February 18, 1992  
LD-92-024

Subject: Response to NRC Requests for Additional Information

Enclosure I to  
LD-92-024

RESPONSE TO NRC REQUESTS FOR ADDITIONAL INFORMATION

Fig. 1 Comparison of Spectral Ordinates Calculated at the Ground Surface with RG 1.60 Anchored to 0.3 g

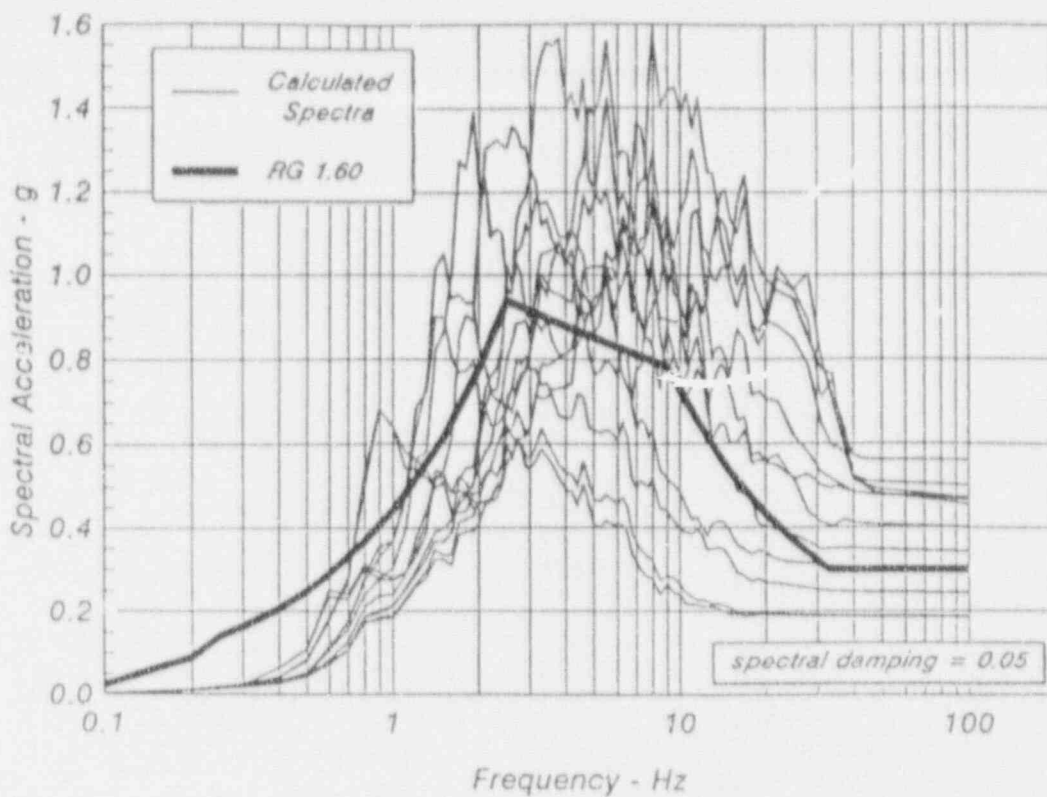
Section 2.5.2.5.1 - The text states that the spectrum is based on work discussed in Reference 1. Provide Reference 1 (P. 2.5-10) and expand the text to explain the basis for spectrum. Include in your explanation the following points:

- The EPRI-ALWR RD presumes a RG 1.60 spectrum with a ZPA of 0.3g.
- The rock outcrop spectrum for eastern North America shown in Figure 2.5-5 is rich in high frequency content. Explain why the frequency content above 50 Hz is not included in the selected horizontal spectrum.

The spectral ordinates calculated at the ground surface of all the soil profiles considered are shown in Figure 1 together with the RG 1.60 spectrum anchored to 0.3 g. As can be noted, the spectra at the ground surface of the soil profiles are equal to or significantly exceed the RG 1.60 spectrum for frequencies higher than about 0.7 Hz. Similarly, as shown in Figure 2, the spectral ordinates at the foundation level are equal to or significantly exceed 0.6 times RG 1.60 spectrum.

Fig. 2 Comparison of Spectral Ordinates Calculated at the Foundation Level with RG 1.60 and with 0.6\*RG 1.60 Anchored to 0.3 g

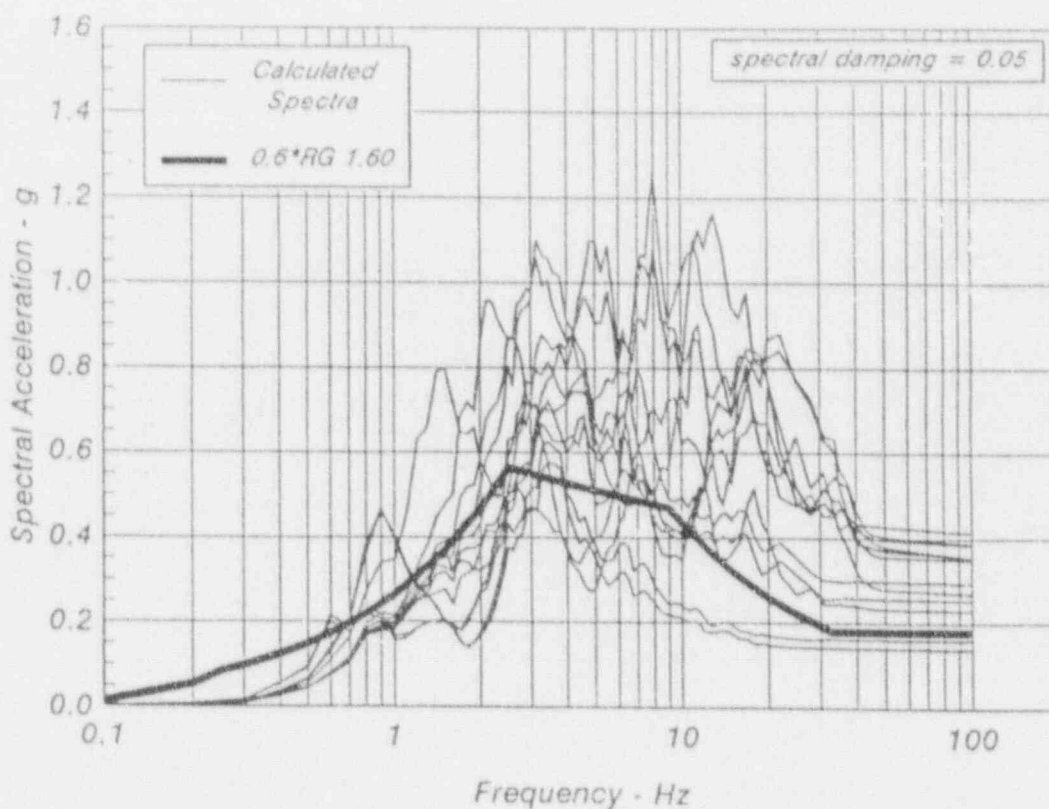
The text states that the spectral ordinates are based on using NUREG-0098; however, the spectral ordinates shown in Figure 2.5-5 are less than those obtained using NUREG-0098 for frequencies lower than 4 Hz.

Thus, the selected System 80+ target spectrum, together with the methodology used in evaluating structures, components and equipment provide a more conservative approach than using the RG 1.60 spectrum directly as input in the evaluation.

Fig. 5 Calculated Horizontal and Vertical Spectra at the Ground Surface for Case B-1

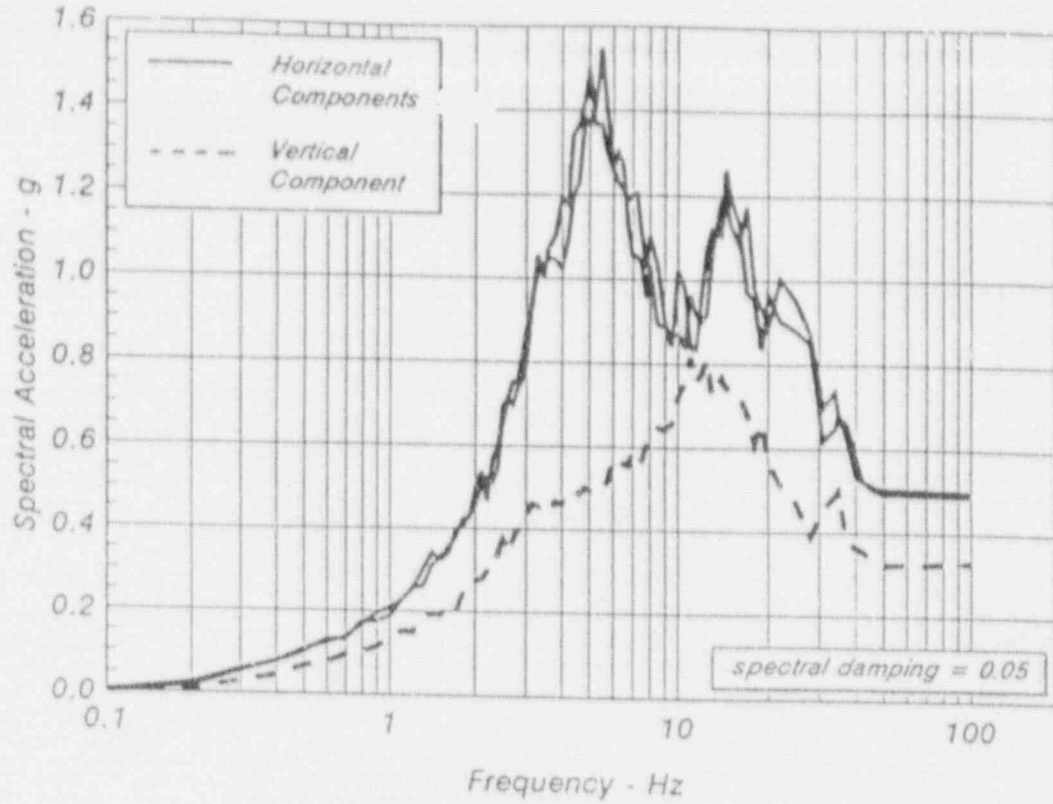
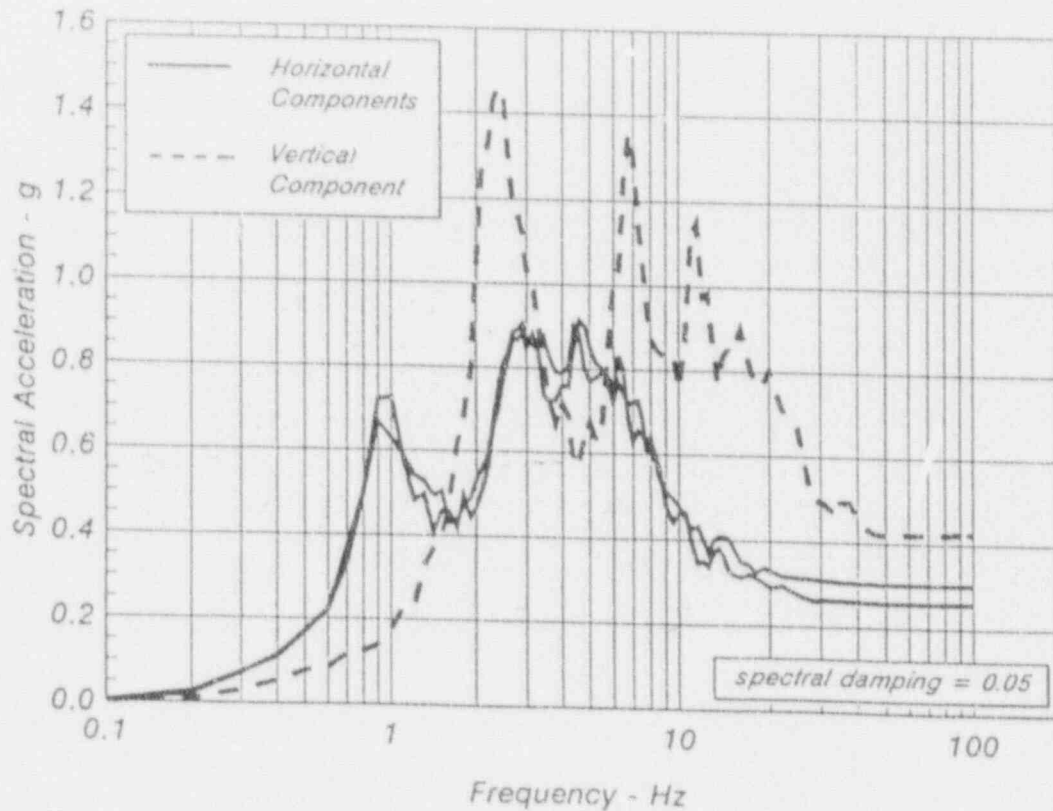
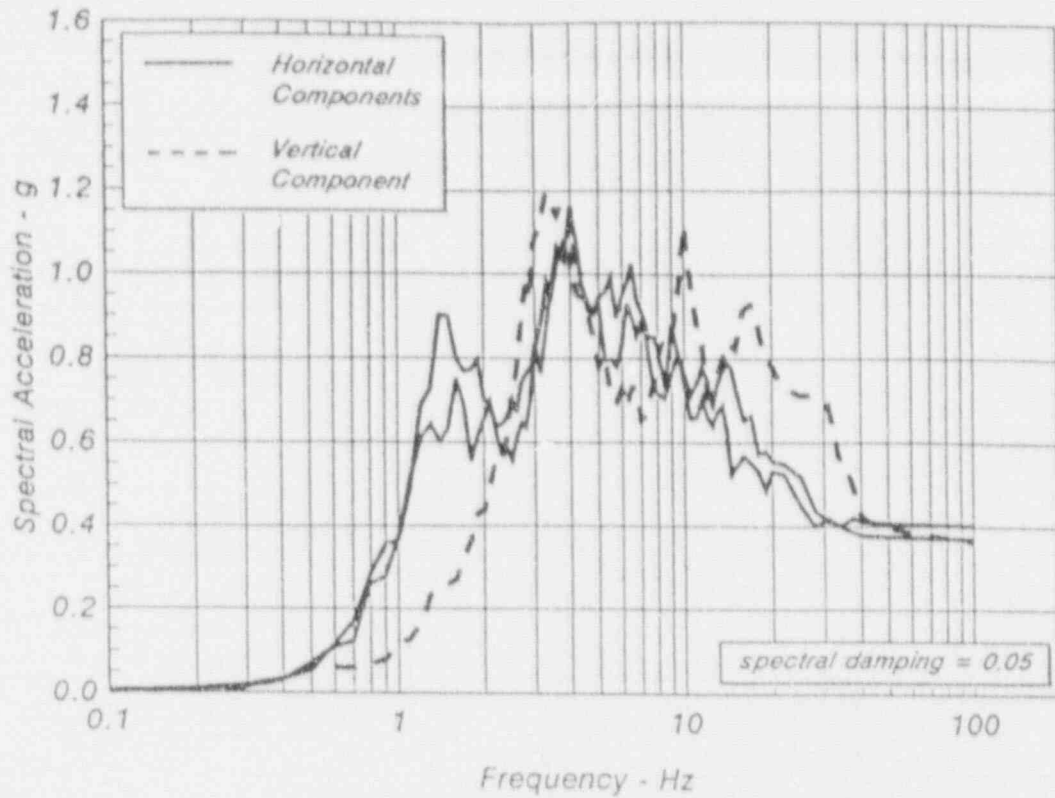
- The text states the vertical component is equal to two-thirds of the horizontal spectrum at all frequencies. However, Revision 2 (dated August 1989) of Standard Review Plan Section 2.5.2 text states that both horizontal and vertical site-specific response spectra should be developed. The staff has questioned the use of the ratio two-thirds because for most plants the controlling earthquake for the SSE is one that is assumed to be near the site and there is data from recorded nearby earthquakes which show that the vertical and horizontal ground motions can be of similar amplitude. At the October 1990 meeting with the staff, CE's consultant had stated that for rock sites the vertical ground motion spectra would be made equal to the horizontal ground motion spectra, while for the soil sites the vertical spectra would remain equal to 2/3 of the horizontal spectra. It is not clear how this suggestion has been implemented in the DC documents.

These variations are illustrated in Figures 5 through 7. Figure 5 shows the spectra for the horizontal components and for the vertical component calculated at the ground surface for Case B-1. The vertical spectral ordinates are smaller than the horizontal spectral ordinates for all frequencies. Figures 6 and 7 show corresponding results for Cases C-3 and C-1.5, respectively. The vertical spectral ordinates for Case C-3 are significantly larger than the horizontal spectral ordinates for frequencies higher than about 6 Hz and in the frequency range of about 1.6 to 3 Hz. For Case C-1.5, the vertical spectral ordinates are comparable to the horizontal spectral ordinates for frequencies higher than about 2.5 Hz.

Fig. 1 Spectral Ordinates Calculated for Case A-0

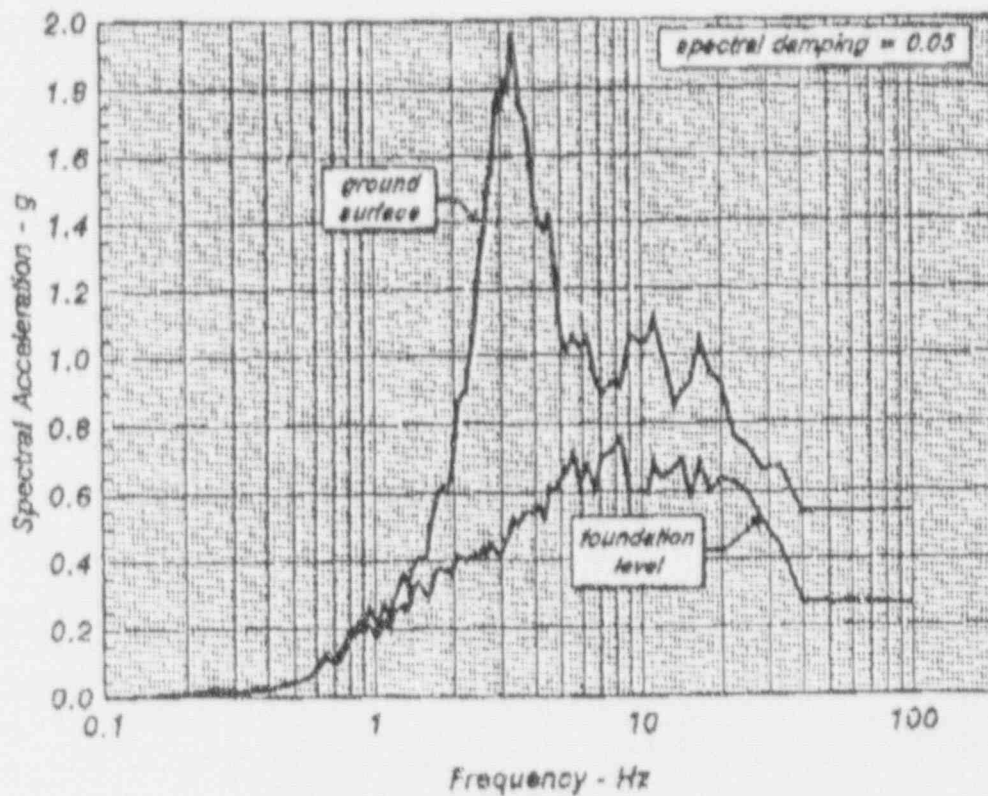
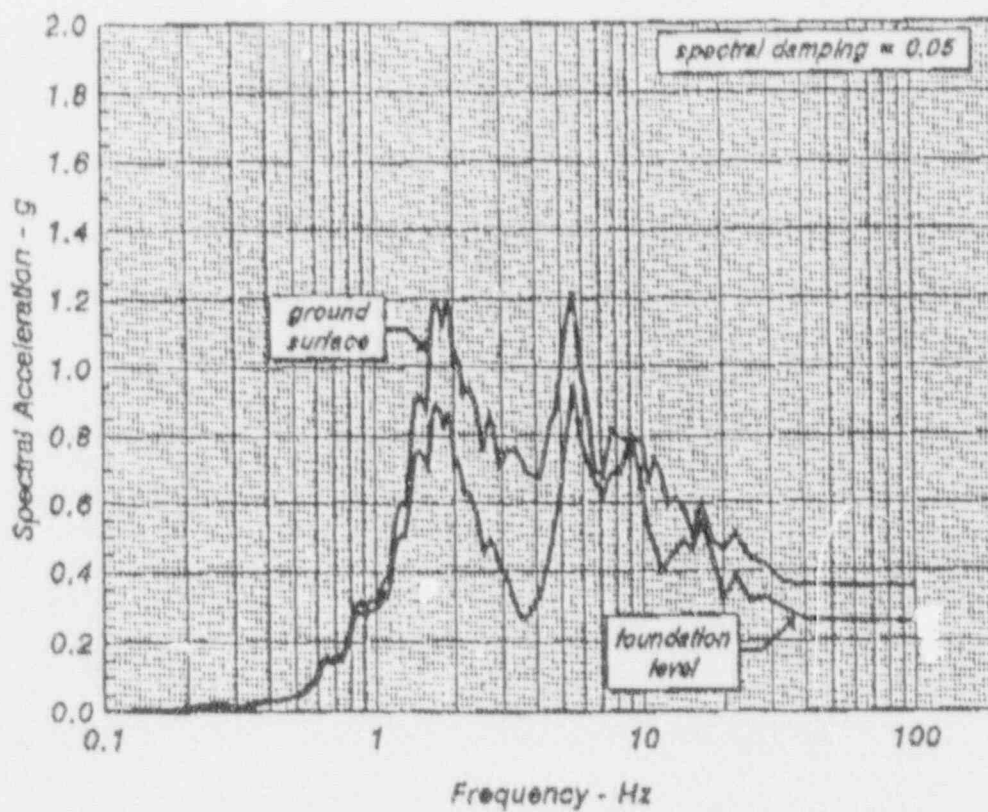
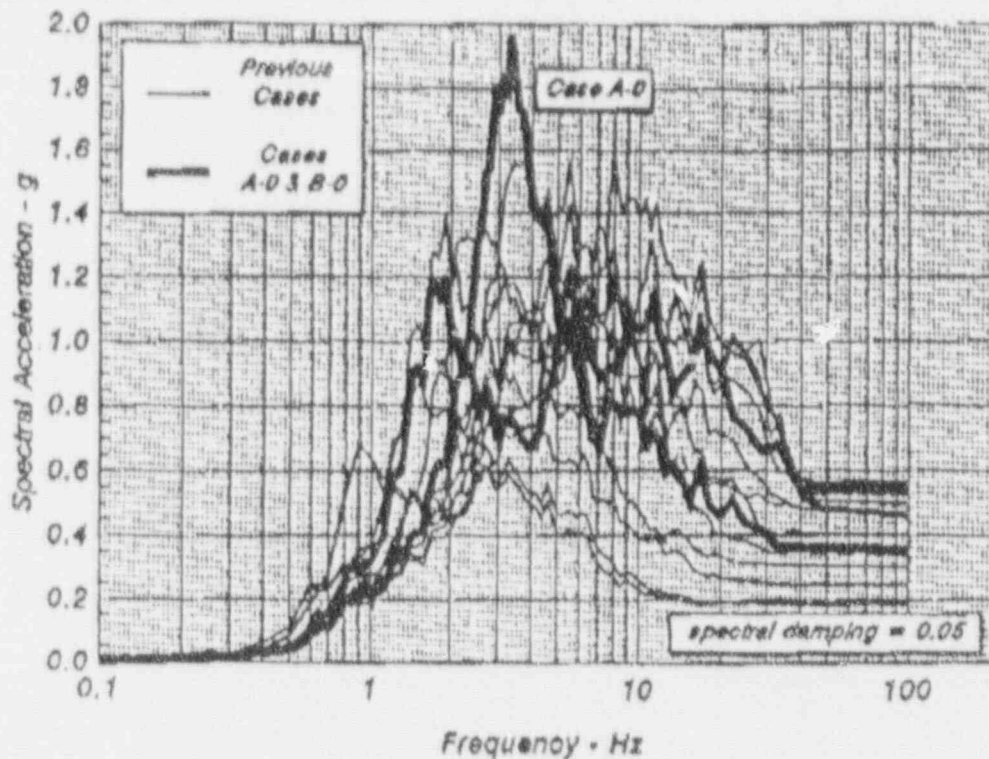
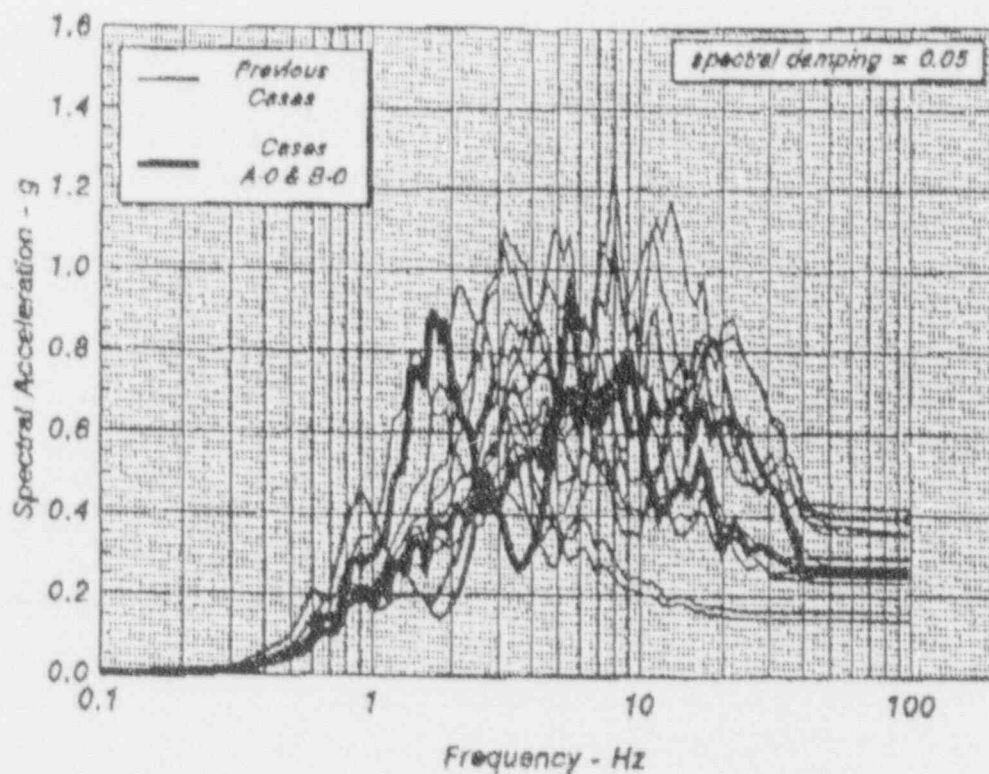
- The LLNL seismic hazard analysis uses spectra. accelerations for different soil categories than those shown on Figure 2A-I. Is the use of different soil categories significant?
- There should be a case of soil with a  $V_s$  of about 1000 ft./sec. over a rock with a  $V_s$  of at least 6000 ft./sec. (see November 13, 1990, Summary of CE System 80+ meeting). Discuss the basis for not considering such a case.

The results of the cases analyzed as part of the System 80+ design and described in CESSAR-DC would cover the results that would be obtained using the range of properties used in the LLNL seismic hazard analysis. Therefore we believe that the range of properties and site categories used for CESSAR-DC are adequate and would cover those selected by LLNL.

In response to this question, a soil layer 52 ft. deep (designated A-0) and a soil layer 100 ft. deep (designated B-0) each having a maximum shear wave velocity  $v_s = 1,000$  fps and overlying a rock half-space whose velocity is equal to 6,000 fps were selected for evaluation. The seismic response of each layer to the synthetic time history H1 was calculated and the results are presented in Figs. 1 and 2. Figure 1 shows the spectral ordinates calculated at the ground surface and at the foundation level for Case A-0; similar plots for Case B-0 are presented in Fig. 2. The results for these cases are compared in Figures 3 and 4 to the spectral ordinates calculated for the previous cases. Figure 3 shows the results at the ground surface and Fig. 4 shows the results at the foundation level. Both figures indicate that the results for these two cases are within the range of the previously calculated cases except for Case A-0 at the ground surface in the frequency range of about 2.6 to about 3.8 Hz. Over this frequency range, the spectral ordinates at the ground surface for Case A-0 exceed the range of the previously calculated cases by no more than about 25 percent.

FIGURE 8.2-2

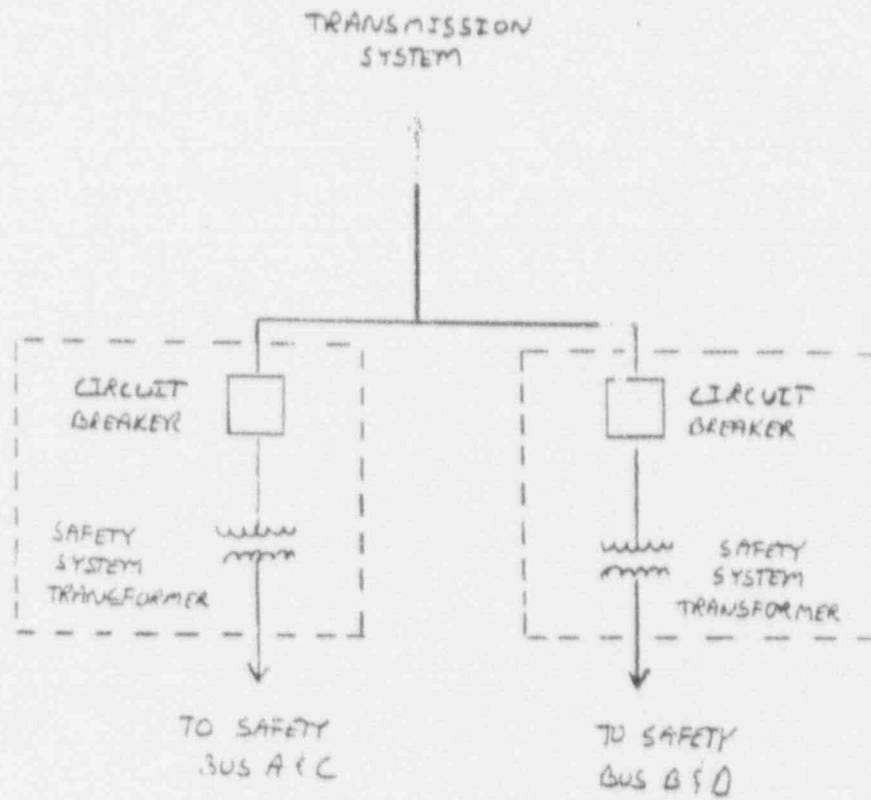
One of the major differences between the distribution systems specified in CESSAR-DC Chapter 8 and those found in most recently licensed nuclear plants is that no alternate power source is provided for the non-safety loads required for unit operation (Figure 8.3.1-1). Since only the safety and permanent non-safety loads have a transfer capability to the reserve source of offsite power, the non-safety loads such as the reactor coolant pumps, feedwater pumps, condensate pumps, and circulating water pumps do not have an alternate source of power. As a result, a loss of power to these loads which could be caused by a failure (fault) anywhere on the Unit Auxiliary Transformers, Main Step-Up Transformers or their connecting feeders results in a plant trip and loss of RCS forced circulation and normal feedwater systems. Reliance must therefore be placed on natural circulation and the safety systems. The CESSAR-DC proposed design therefore results in increased reliance on the challenges to the safety systems, and perhaps more frequent excursions towards peak clad temperatures. We therefore recommend that you evaluate alternatives that would provide a second source of power to these non-safety loads.

"A third separate and independent transmission line is connected to a switchyard containing two circuit breakers and safety system transformers, as illustrated by Figure 8.2-2, to provide another source of offsite power to the 4160V safety buses."
